### Response to Submissions

Eliwana Iron Ore Mine, EPA Assessment 2125.

EW-RP-EN-0003.001\_2

Figure 47

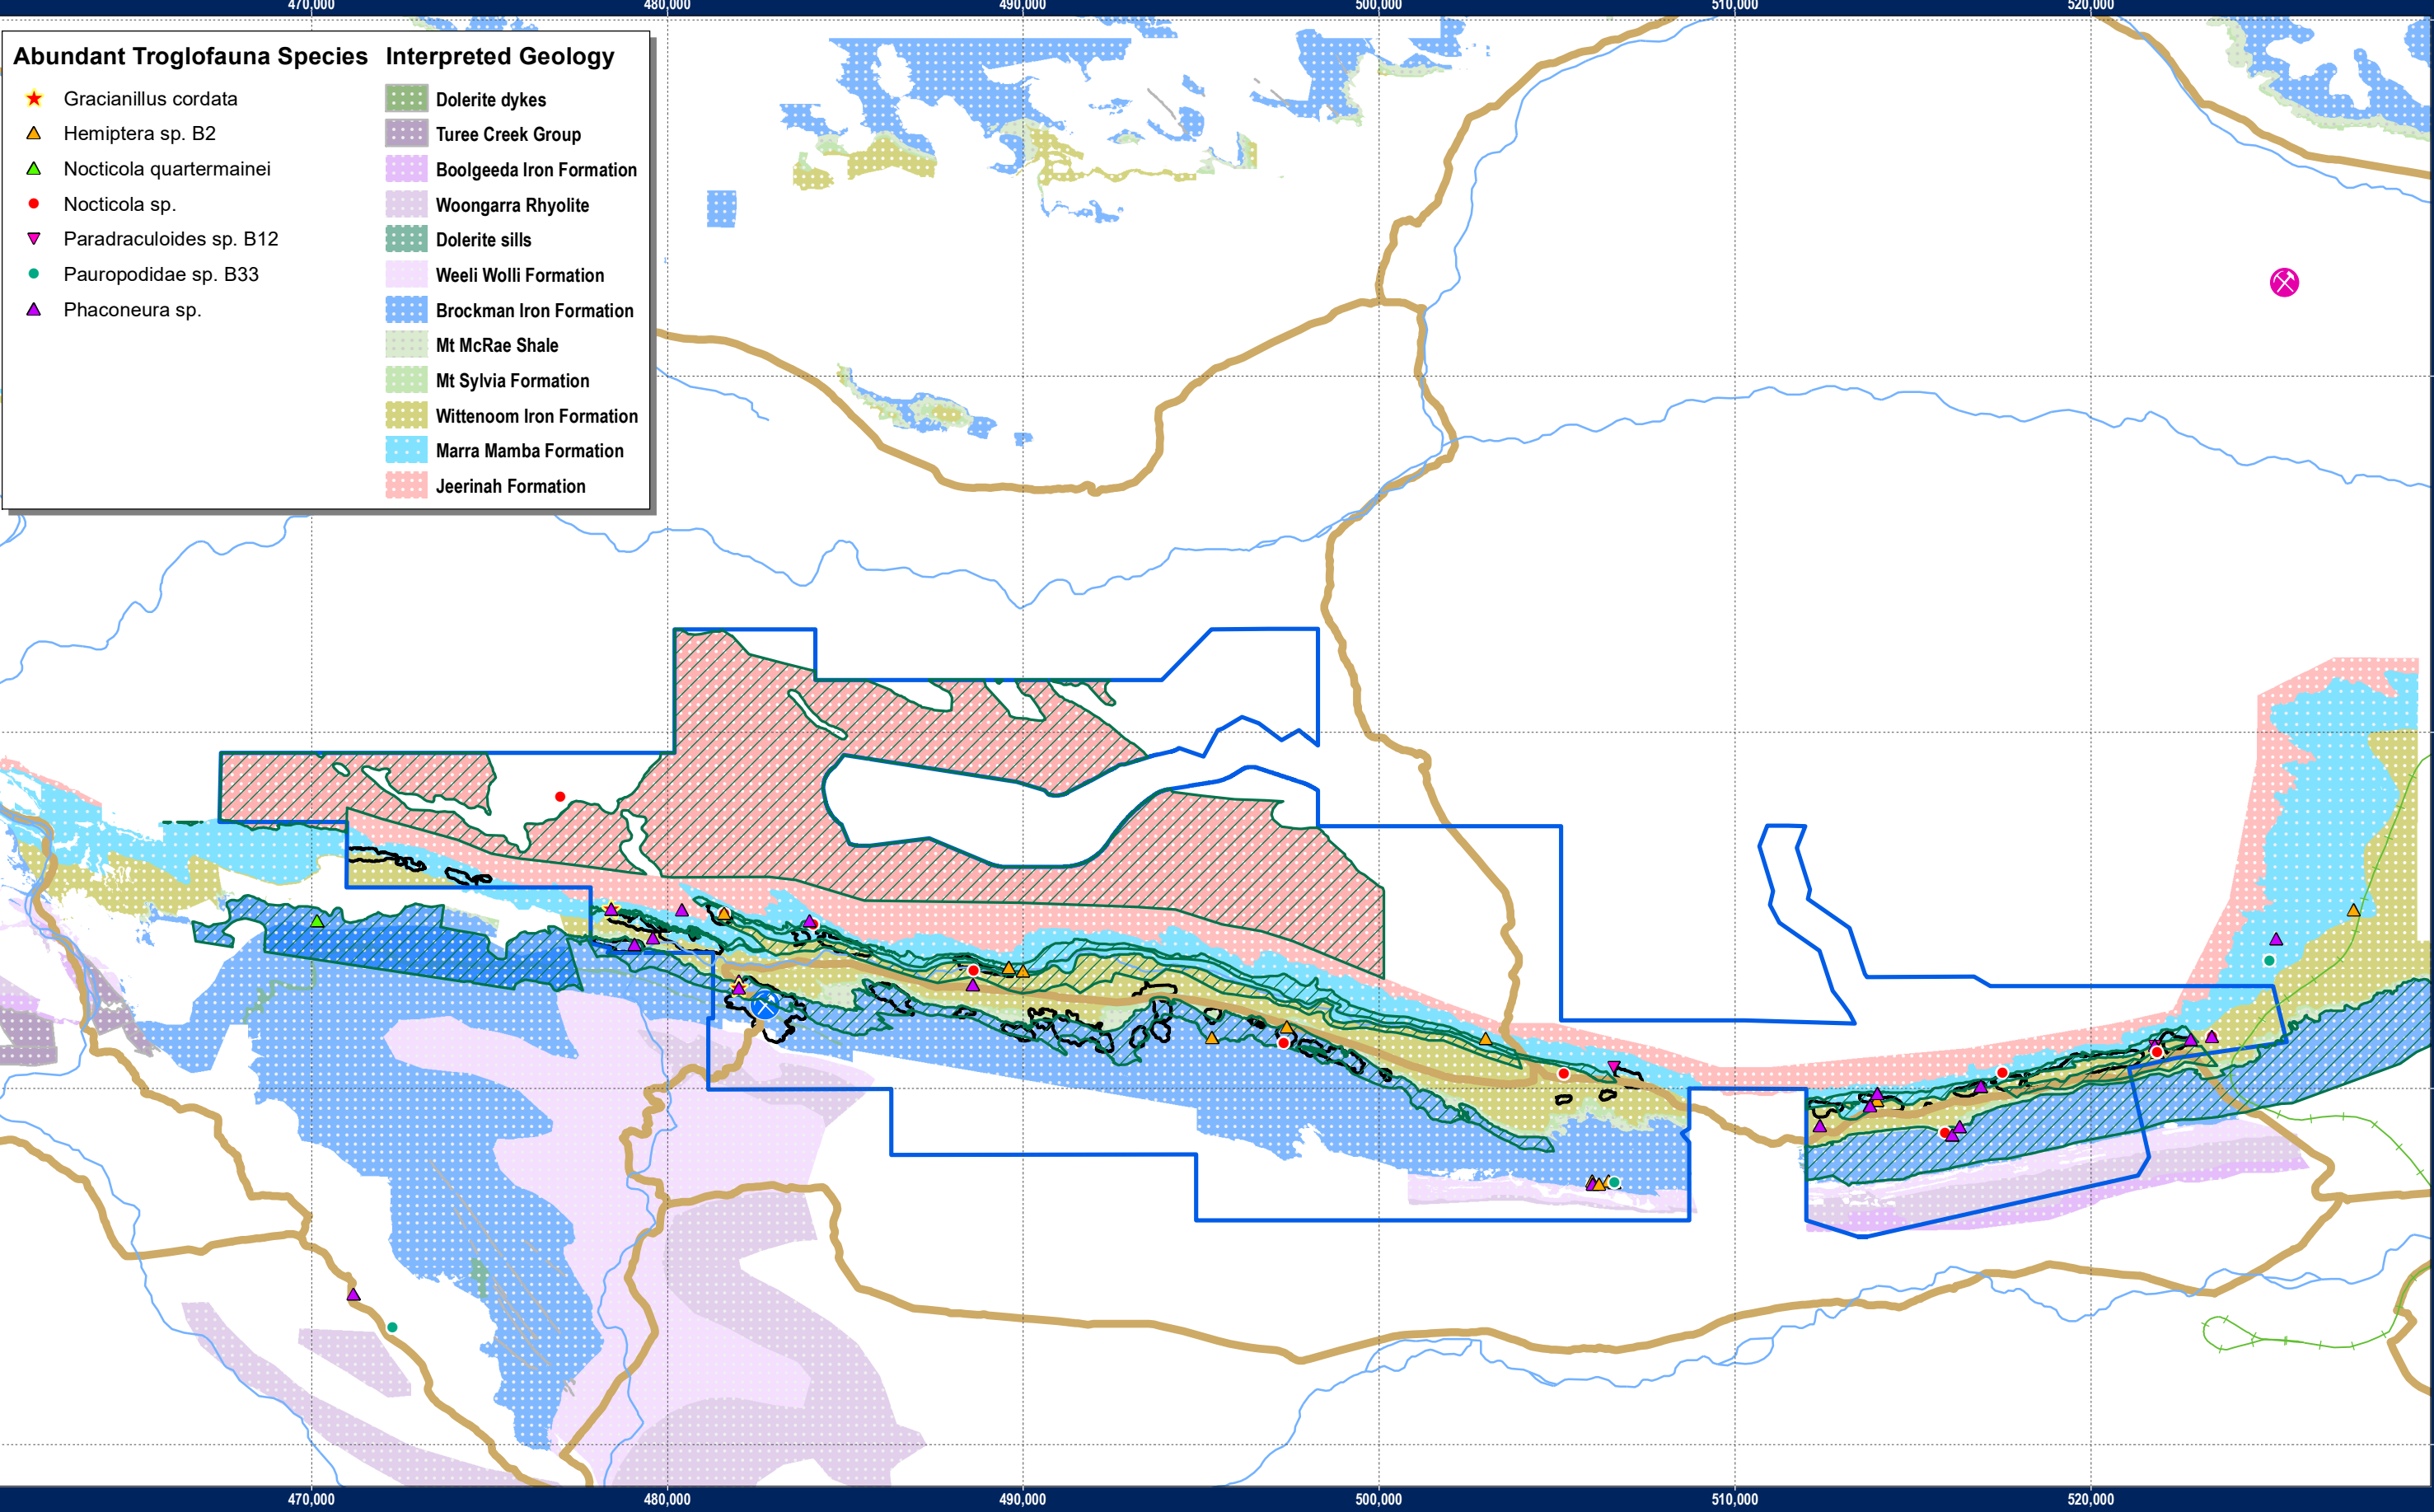
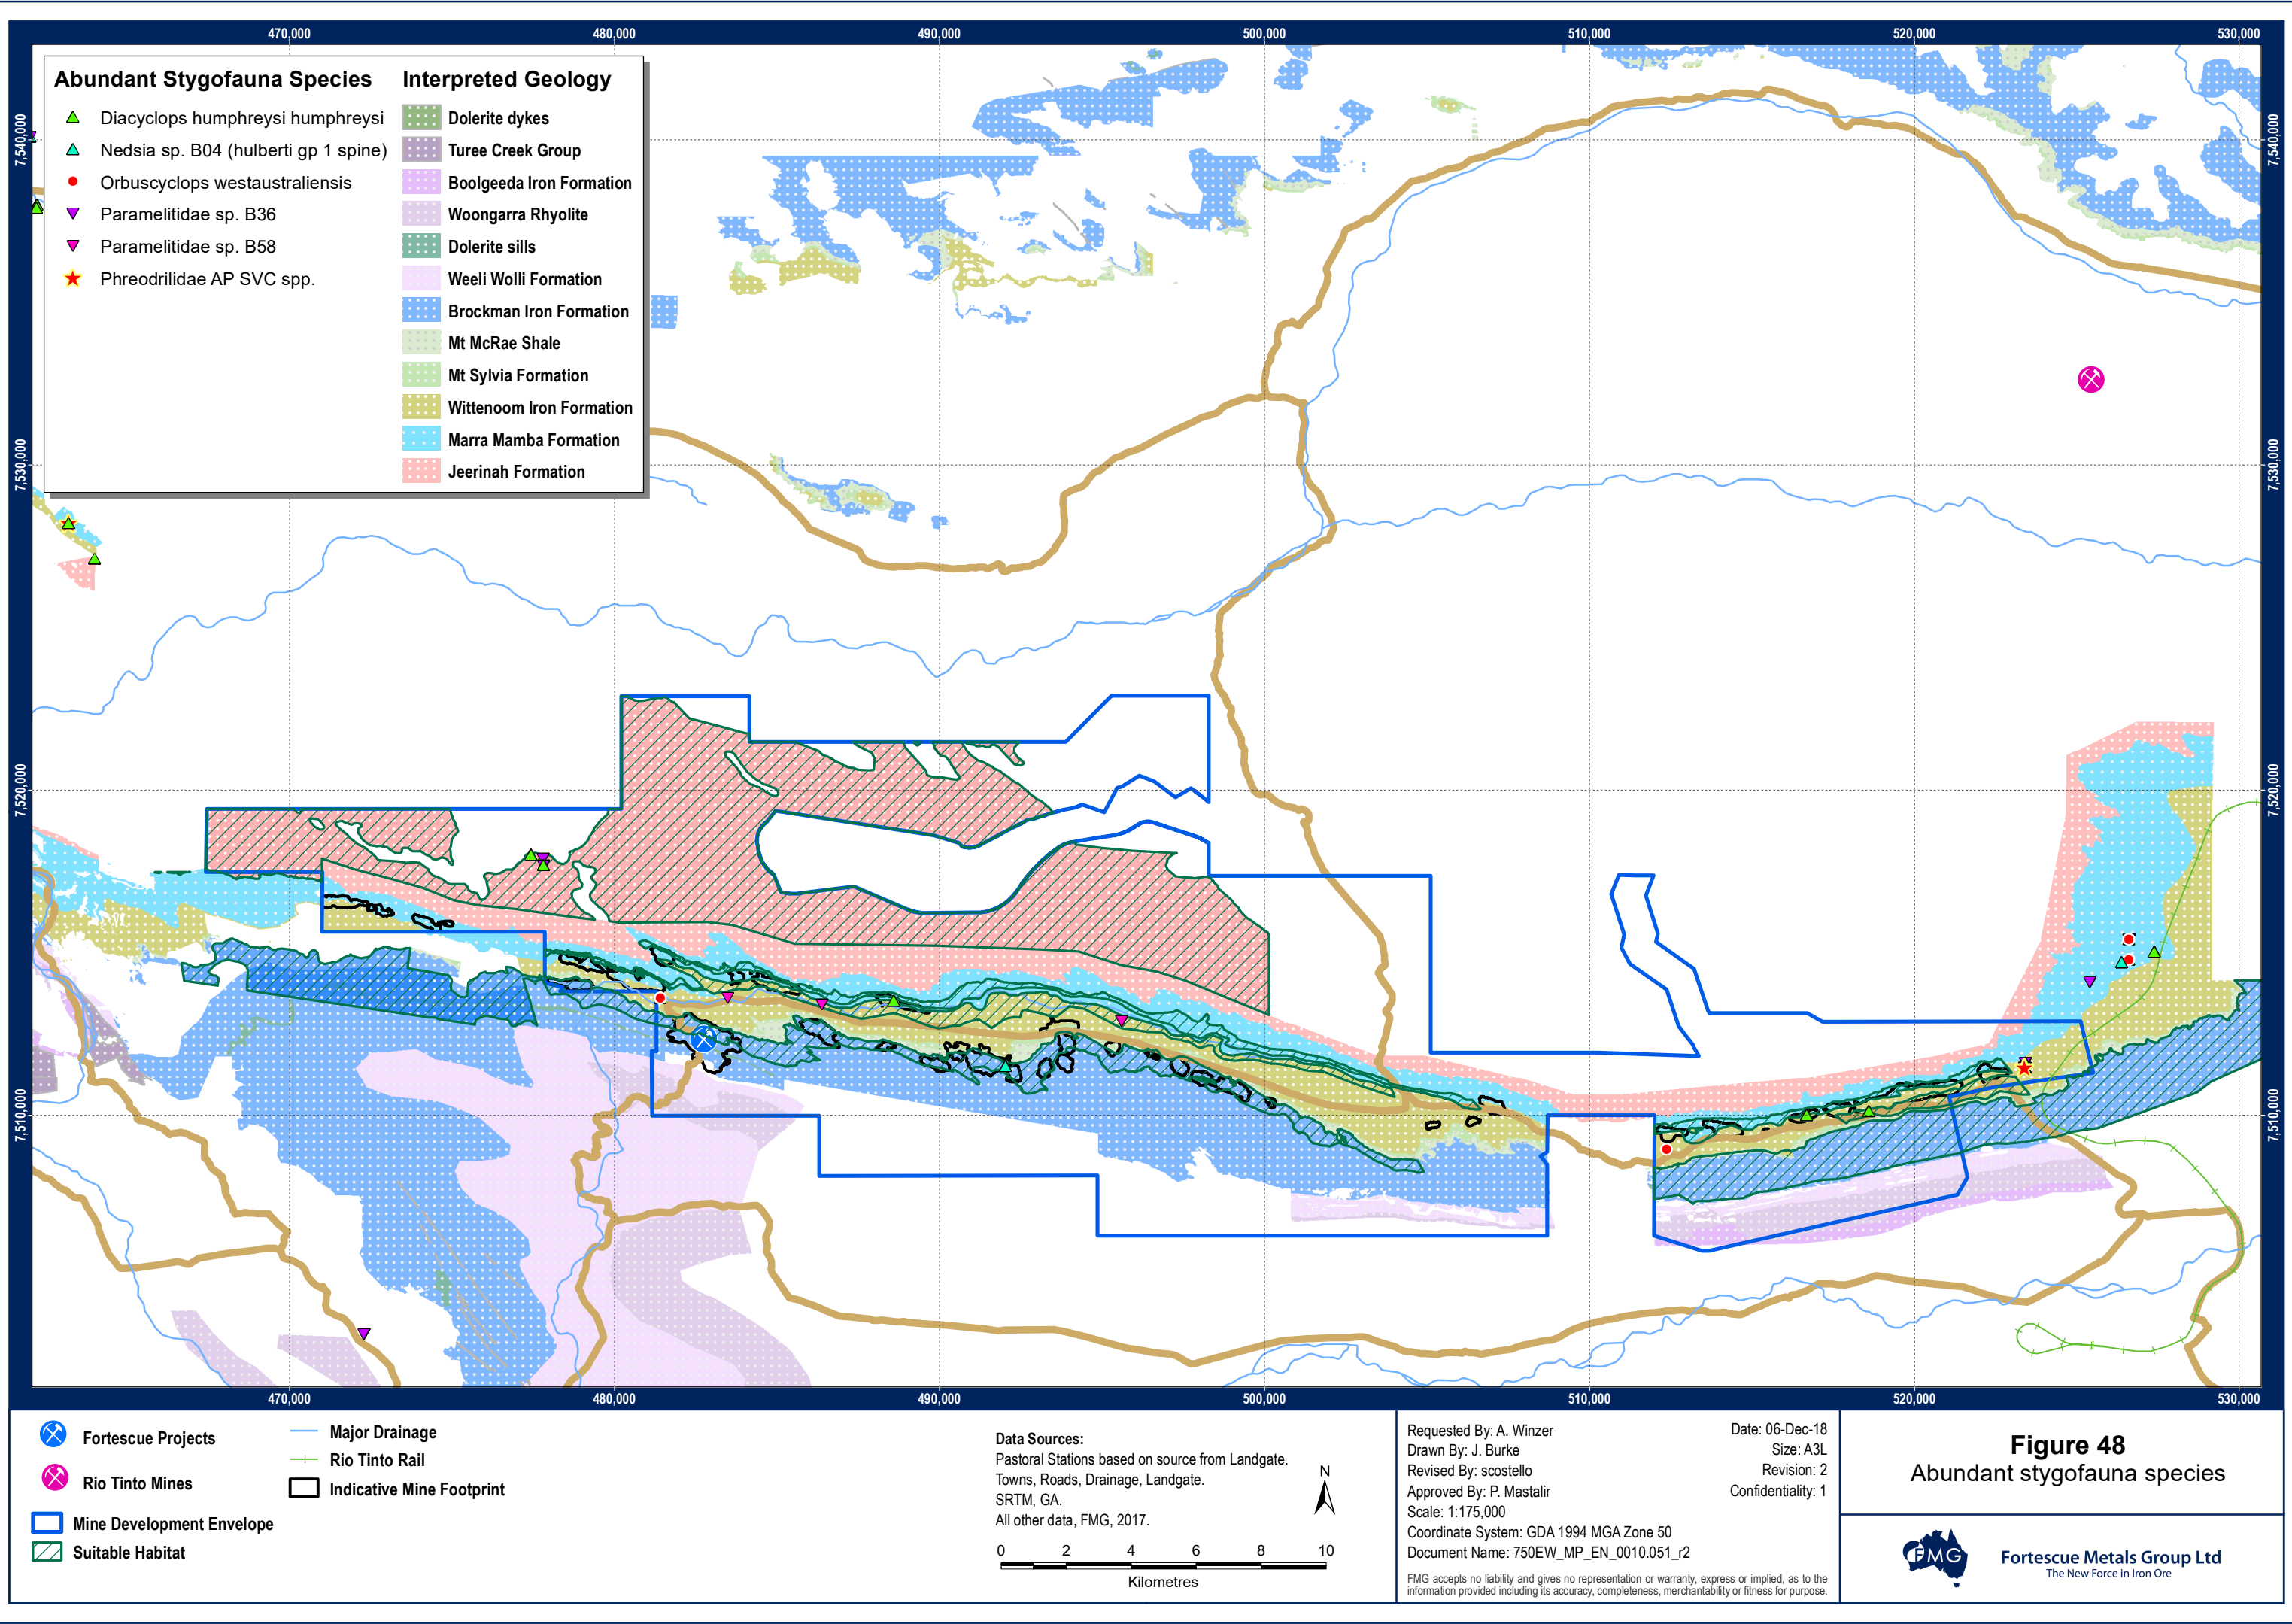
28	DWER (TEB)	<p>The information presented in the ERD for Subterranean Fauna contains significant errors and inconsistencies, which impeded accurate assessment of the impacts to individual species. There are inconsistencies between the information presented in the tables and figures, and there are differences in the results presented in the ERD and those presented in the technical report, Appendix 21, as listed below:</p> <p><b>Troglofauna</b></p> <ol style="list-style-type: none"> <li>Several species listed in Table 45 &amp; 46 not illustrated in Figure 32.</li> <li>The species selected as biological surrogates are unsuitable i.e. <i>Nocticola</i> sp. and <i>Phaconeura</i> sp. cannot be surrogates as 'sp' indicates that the species is not known.</li> </ol>	<p>Each dot point in this comment is addressed below</p> <p><b>Troglofauna</b></p> <ol style="list-style-type: none"> <li>Table 45 of the ERD lists potentially restricted troglofauna species by location i.e. pit name and corresponding cross section (cross sections indicated in Figure 32). Figure 32 in the ERD shows 16 potentially restricted troglofauna, this has been updated to include 17 (as per Appendix 21 -Table 7.1). Note, several species were found to occur at the one location and therefore may not have been visible in the figure (each species icon was placed on top of another). This may account for the disparity between the figure and the table. The amended figure displays all species with greater clarity.</li> <li>The only species selected as a biological surrogate within Section 4.8.5.2 of the ERD, is Pauropodidae sp. B33 which Fortescue note the TEB has confirmed is acceptable. The same section of the ERD refers to Figure 47 – “Abundant troglofauna species” only for the</li> </ol>

No.	Commentator	Comment	Response
			<p>7. Similar to Figure 47 (see Abundant Troglifauna) the Abundant Stygofauna species figure (Figure 48 of the ERD) includes the suitable habitat layer to convey the extent of suitable habitat. The drawdown layer is not required to convey habitat extent. As such Figure 48 has not been amended.</p> <p>8. As discussed for the troglifauna comment above, stygofauna species with widespread distributions were used to demonstrate habitat connectivity, not as biological surrogates for potentially restricted species. Section 4.8.5.4 of the ERD uses Paramelitidae sp. B36 as a biological surrogate for Paramelitidae sp. B58.</p>
29	DWER (TEB)	<p>The maps and figures presented in Appendix 21 are of a better standard and more comprehensive than those presented in the ERD. However, there are differences between the information presented in the ERD, as below:</p> <ul style="list-style-type: none"> <li>The locations and distributions of some subterranean fauna species as presented in the technical report are different to those shown in the ERD. For example, Paramelitidae sp. B58, <i>Lepidospera</i> sp. B10, <i>Paradraculoides</i> sp. new 2, <i>Paradraculoides</i> sp. B12A, <i>Troglarmadillo</i> sp. B46.</li> <li>Figure 6.2 (Appendix 21) includes the locations of species that are not presented in the ERD e.g. stygofauna species: <i>Brevisomabathynella</i> sp. A and sp. B; troglifauna species: <i>Prethopalpus</i> sp. MW21, Campodeidae sp. EW, <i>Palpigradi</i> sp, Pauropodidae sp. B42 and 43 (see ERD Figure 42 – Map 1).</li> <li>Appendix 21 includes an additional troglifauna species <i>Paradraculoides</i> sp. new3, recognised as being genetically distinct from <i>Paradraculoides</i> sp. new2. The ERD does not discuss the omission of this species from the assessment.</li> </ul> <p>The information presented in the ERD should be checked against the results presented in Appendix 21. The proponent should confirm whether the information presented in Appendix 21 is accurate to inform the assessment.</p>	<p>The purpose of the ERD is to present an environmental impact assessment of the Proposal for public review and assessment by the EPA. The ERD includes a detailed impact assessment and description of proposed mitigation and management measures for the environmental factors identified in the Environmental Scoping Document (ESD).</p> <ul style="list-style-type: none"> <li>Figure 32 (sheet 1 and 2) has been amended with annotations showing each of the 16 potentially restricted troglifauna species. The five potentially restricted species found at bore (EW1061) inside Broadway pit are also listed in Table 45 of the ERD.</li> <li>Figure 32 and 42 have been amended as discussed.</li> <li><i>Paradraculoides</i> sp. New3 is not listed in the ERD as the Eliwana mine footprint was reduced in size after the Biologic (2018) report was finalised (Appendix 21). <i>Paradraculoides</i> sp. New3 no longer occurs within the MDE. Therefore, the ERD discusses 16 potentially restricted troglifauna whilst Appendix 21 discussed 17 species.</li> </ul>
